NNB GenCo proposal to modify the design of Hinkley Point C

**Request for agreement under Licence Condition 20 of Nuclear Site Licence No. 97A:
Reflective Metal Insulation Replacements and Fibre Removal from the Reactor Building**

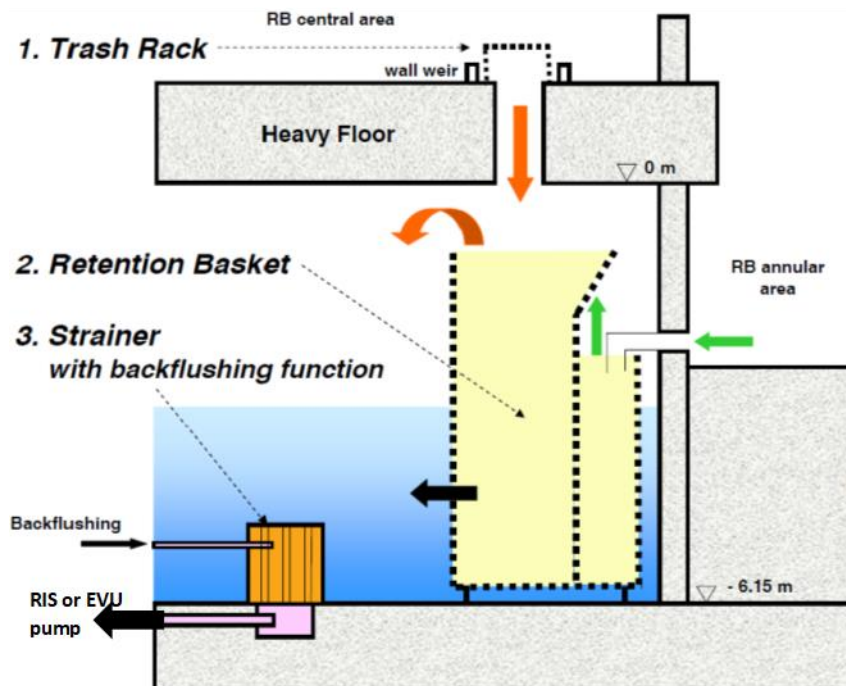
4. Filtering grills and filters are installed to prevent debris flowing from the containment to the IRWST during postulated accident conditions and to protect EVU and RIS pumps respectively. See the figure below.
